**J-3 Comments on the Draft EA
and FAA Responses**

Comments and Responses Volume 2

RE: Comments on the FAA’s South-Central Florida Metroplex Draft Environmental Assessment

FLL Comments - FAA South-Central Florida Metroplex Draft EA - July 23, 2020

FLL CUUDA STAR – 47% of Jet Arrivals

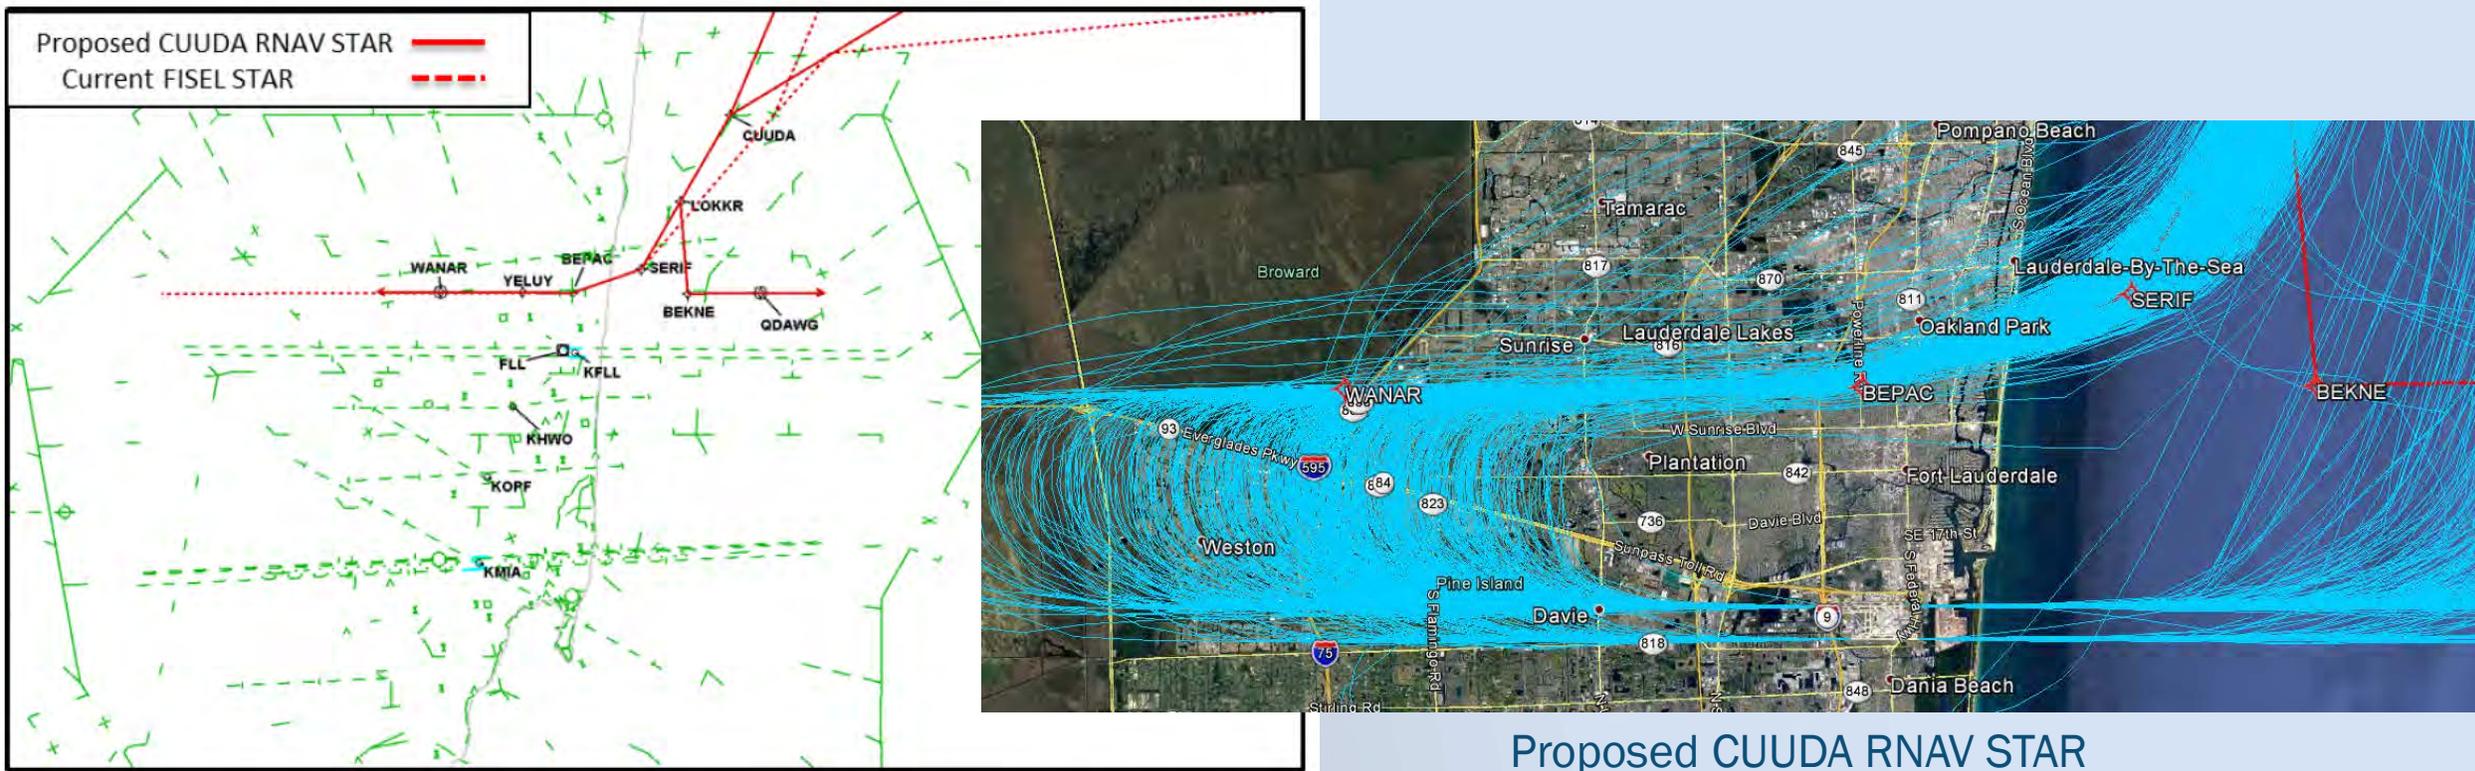
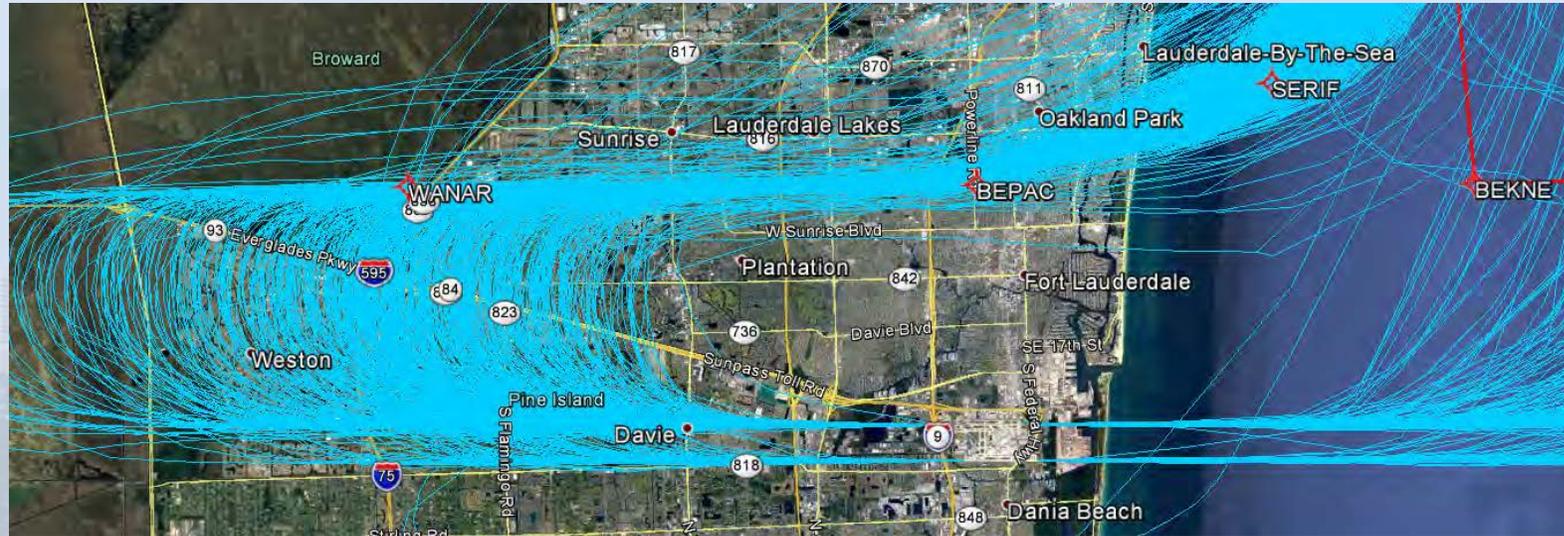
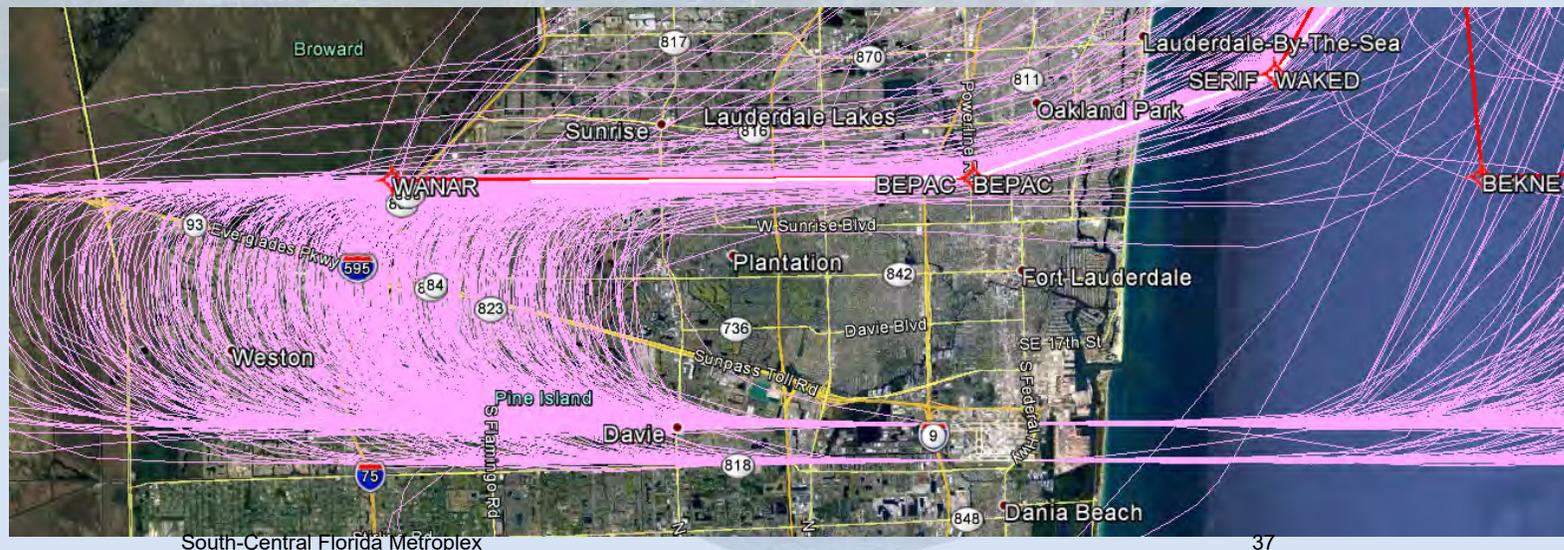
Broward County Aviation Dept. (BCAD)	Winston Cannicle, Noise Information Officer, wcannicle@broward.org; 954-359-6181	FLL	CUUDA STAR	East Fort Lauderdale, Oakland Park, Wilton Manors, Las Olas; Plantation, Sunrise	It appears that the CUUDA STAR generally replicates the existing FISEL STAR with some increased dispersion as aircraft cross the coast north of the airport. Any changes in frequency of use could result in community concerns.	Slides 26-27 Attachment A
Broward County Aviation Dept. (BCAD)	Winston Cannicle, Noise Information Officer, wcannicle@broward.org; 954-359-6181	FLL	OLAAS STAR	Riviera Isles, , Las Olas Isles, East Fort Lauderdale, Victoria Park, South Middle River	Arrivals on the north downwind will be shifted farther to the north and further concentrated as they cross the coast to use the BEPAC waypoint resulting in increased overflights between KEVEY and BEPAC over areas northeast of the airport. This could result in community concerns.	Slides 29-30 Attachment A

Broward County Aviation Dept. (BCAD)	Winston Cannicle, Noise Information Officer, wcannicle@broward.org; 954-359-6181	FLL	CUUDA STAR	Arrival	East Fort Lauderdale, Oakland Park, Wilton Manors, Las Olas; Plantation, Sunrise	In east flow, the downwind leg shifts arrivals to Runway 10 over the coast and increases overflights to some populated areas along the extended downwind. While these areas already receive overflights, the increase could result in community concerns. Additionally, while areas between BEPAC and WANAR already receive over-flights, the increase could result in community concerns.			No change made. It appears that the CUUDA STAR generally replicates the existing FISEL STAR with some increased dispersion as aircraft cross the coast north of the airport. This could result in community concerns.
Broward County Aviation Dept. (BCAD)	Winston Cannicle, Noise Information Officer, wcannicle@broward.org; 954-359-6181	FLL	OLAAS STAR	Arrival	Riviera Isles, Las Olas Isles, East Fort Lauderdale, Hendricks and Venice Isles, Victoria Park, South Middle River	In east flow, arrival traffic between KEVEY and BEPAC will be concentrated over areas previously not experiencing high traffic volumes and introduces new over-flights over highly populated areas and could result in community concerns	Include waypoint LAYYI to procedure. ->KEVEY->LAYYI->BEPAC		No change made. Arrivals on the north downwind will be shifted farther to the north as they cross the coast to use the BEPAC waypoint resulting in increased overflights between KEVEY and BEPAC over areas northeast of the airport. This could result in community concerns.

FLL TEEKY STAR – 33% of Jet Arrivals

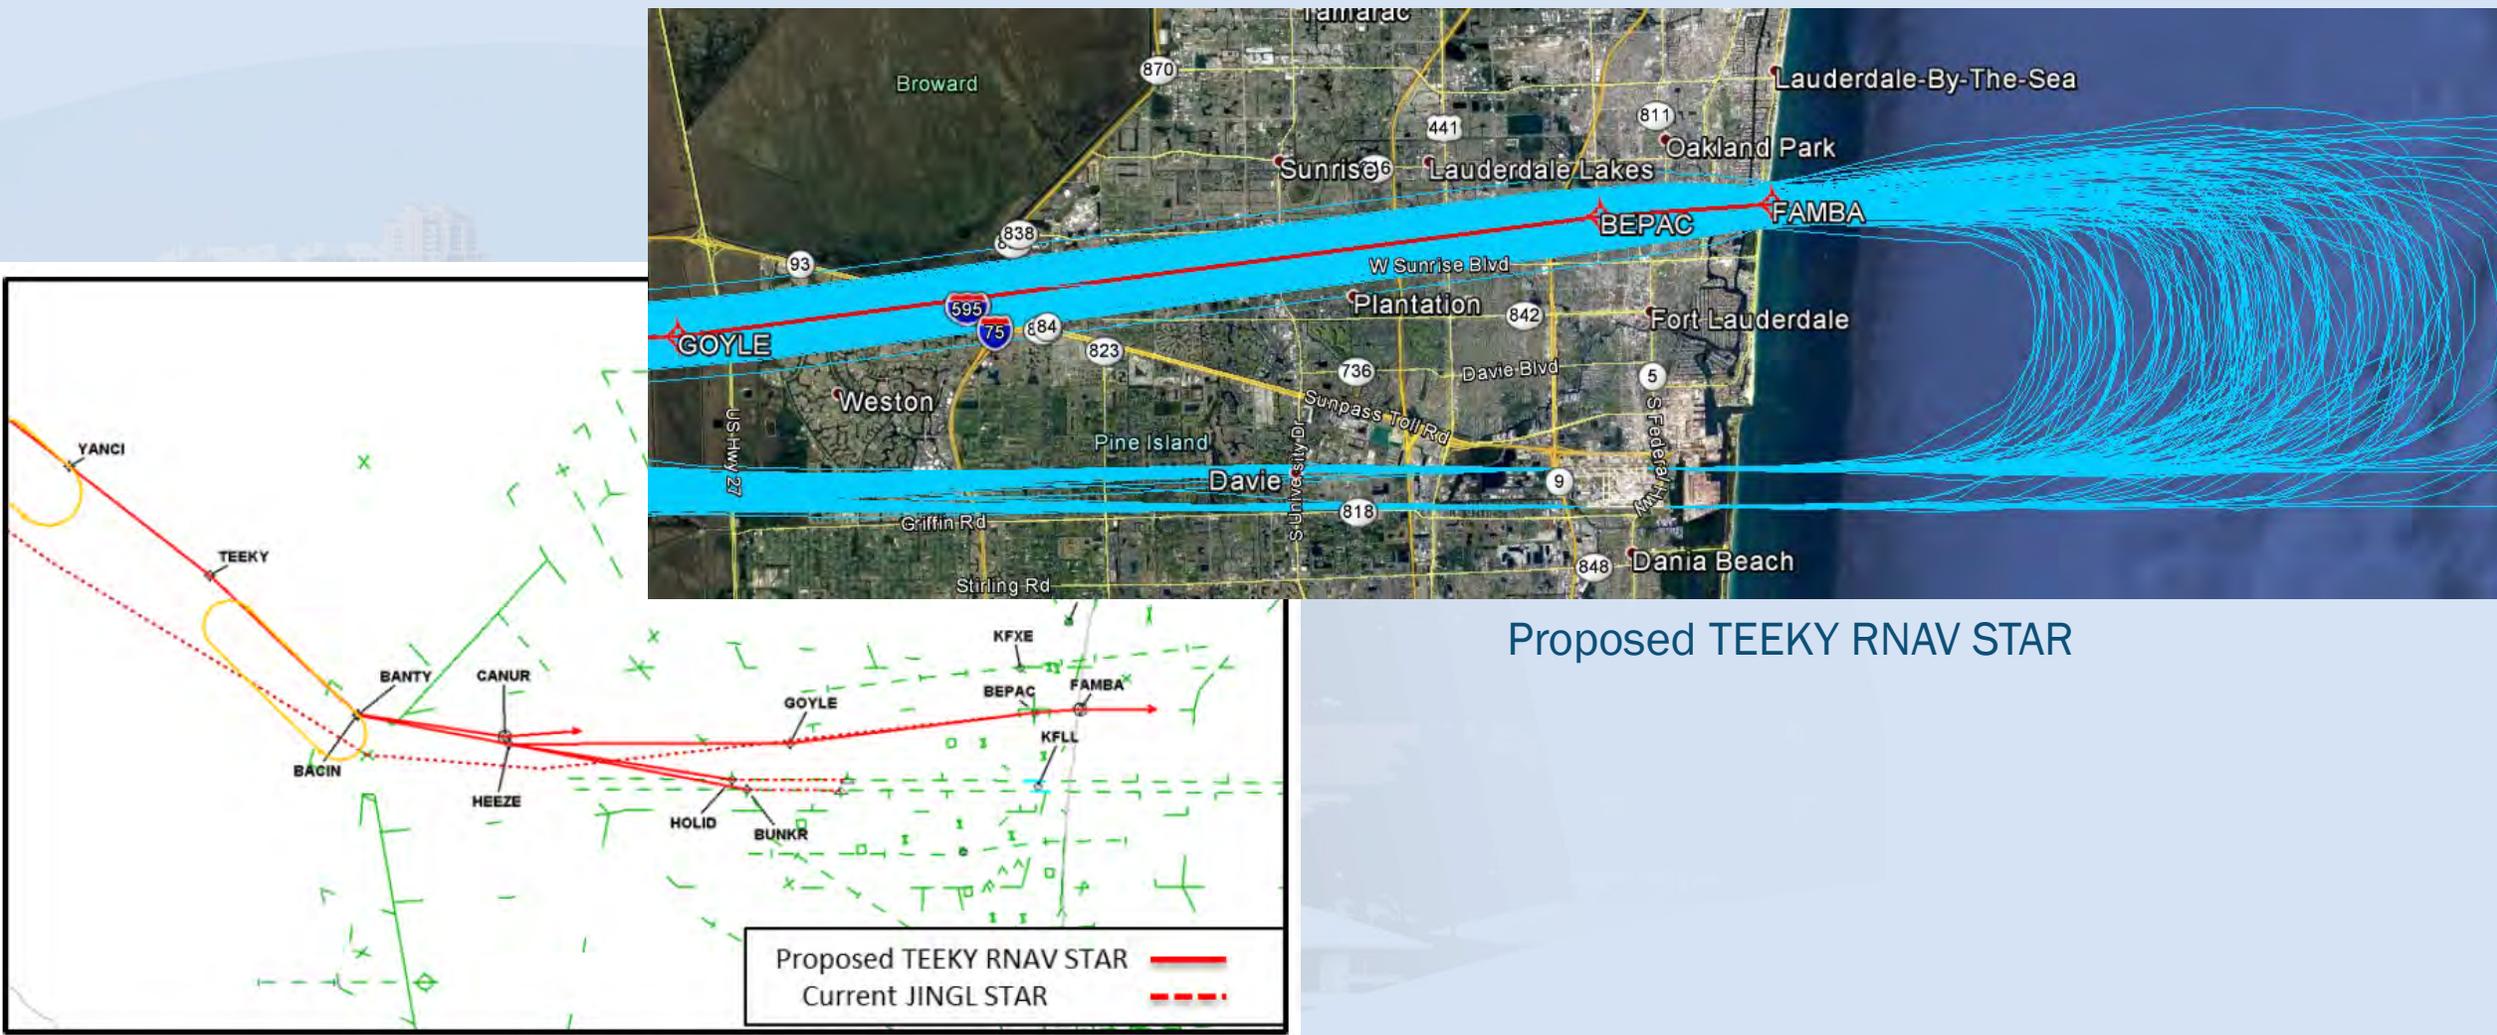
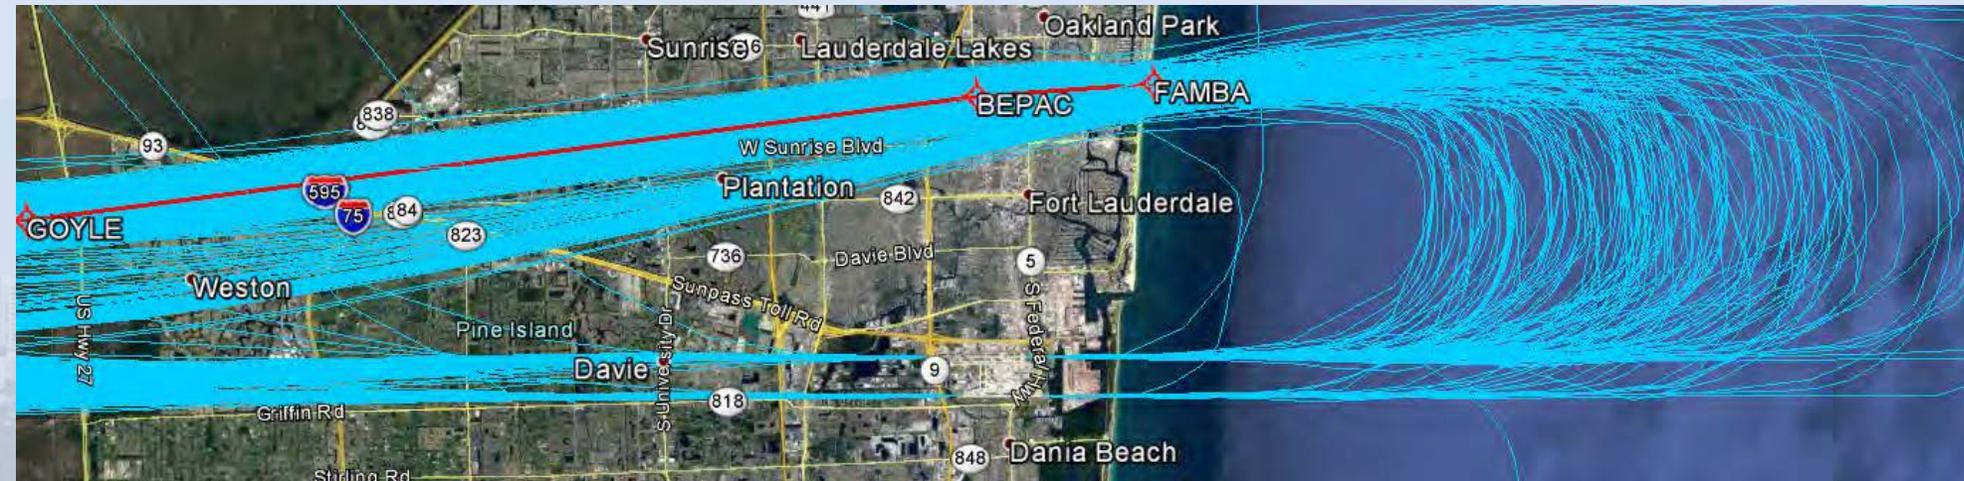
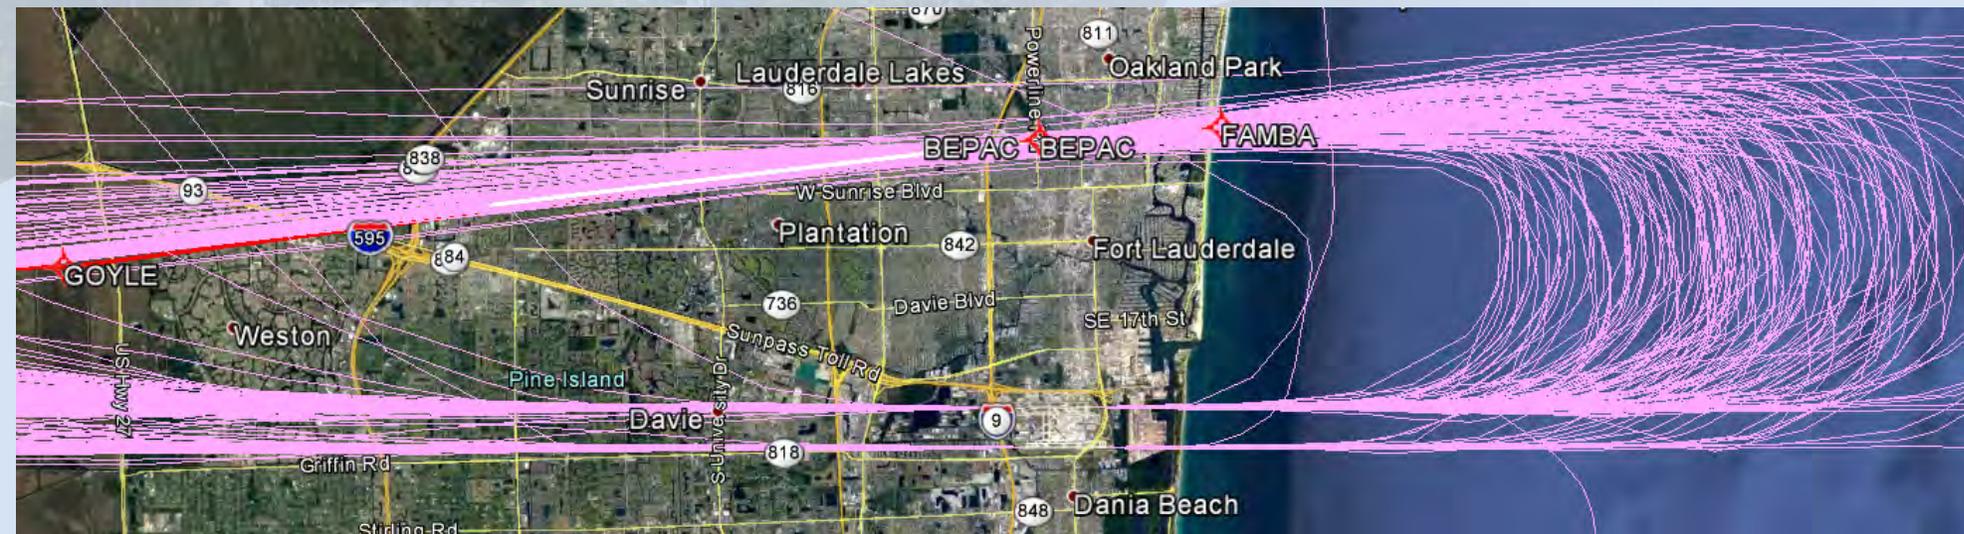
Broward County Aviation Dept. (BCAD)	Winston Cannicle, Noise Information Officer, wcannicle@broward.org; 954-359-6181	FLL	TEEKY STAR	Arrival	Weston and West Plantation	The downwind leg for arrivals to Runway 28 shifts slightly north overflying new residents in Weston and Plantation between GOYLE and BEPAC. This could result in community concerns.			No change made. The TEEKY STAR largely replicates the JINGL STAR while vectoring may result in more higher altitude overflights of west and plantation during west flow. This could result in community concerns.
Broward County Aviation Dept. (BCAD)	Winston Cannicle, Noise Information Officer, wcannicle@broward.org; 954-359-6181	FLL	CONCK SID	Departure	Dania, Davie, Weston, Cooper City, SW Ranches	Provides straight-out departure fixes to TIDEZ and SEAZZ consistent with some current operations. Not clear how this will affect or change operations, however, this will likely result in community concerns.			FAA removed procedure from Metroplex project

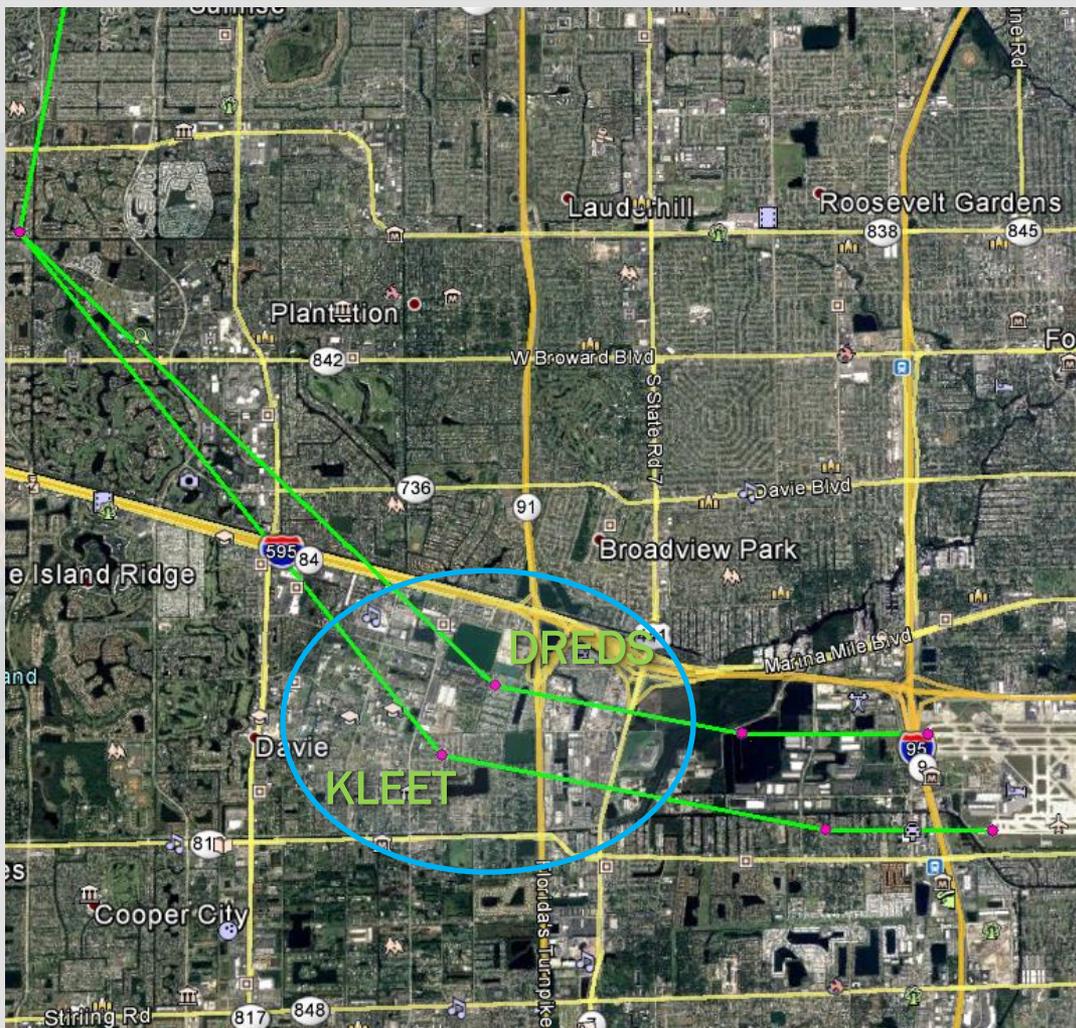
A westward shift in the departure segment between the SHELZ and AGERS waypoints would avoid direct overflights of a number of communities in western Broward County

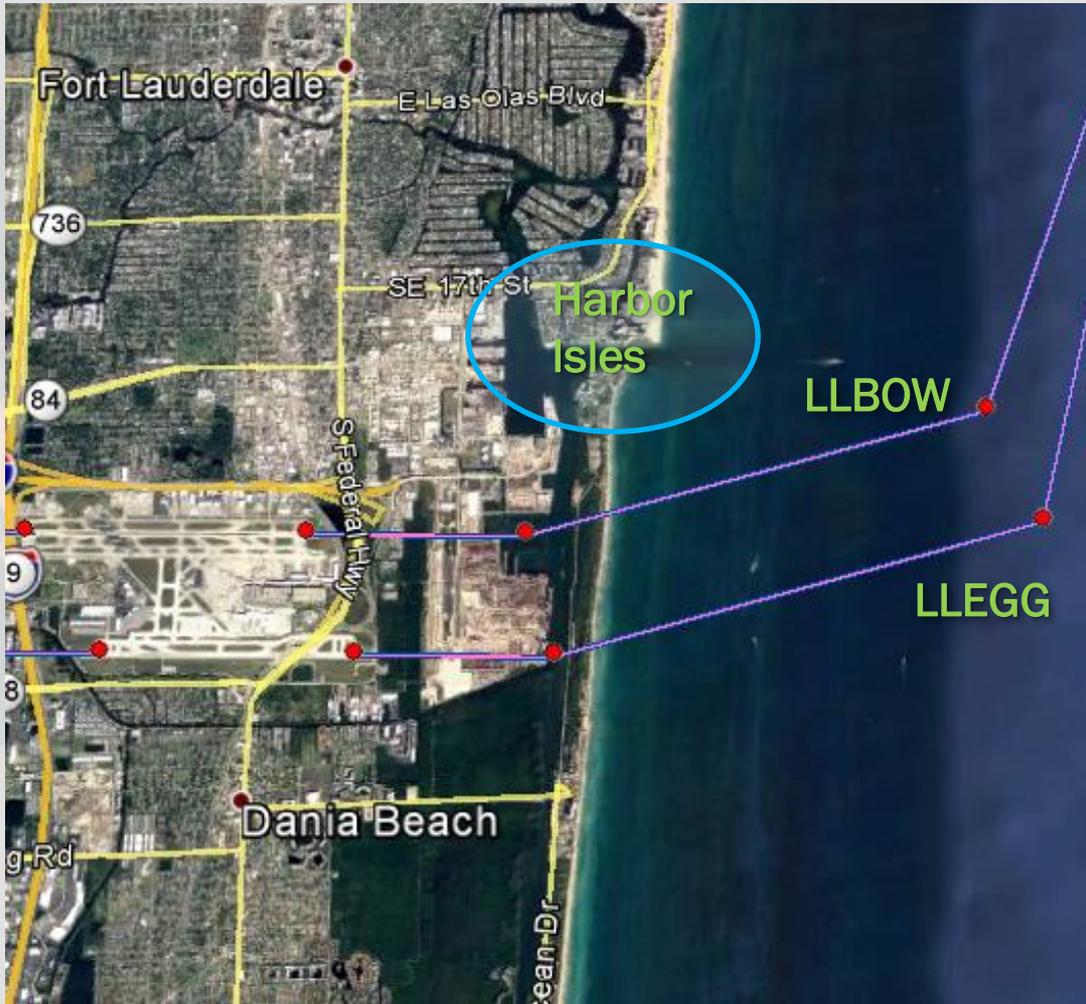
DREDS and KLEET are flyby waypoints with a 287 heading. Changing them to flyover waypoints or a shift further south would help keep aircraft in the compatible corridor south of I-595 longer during climb out.
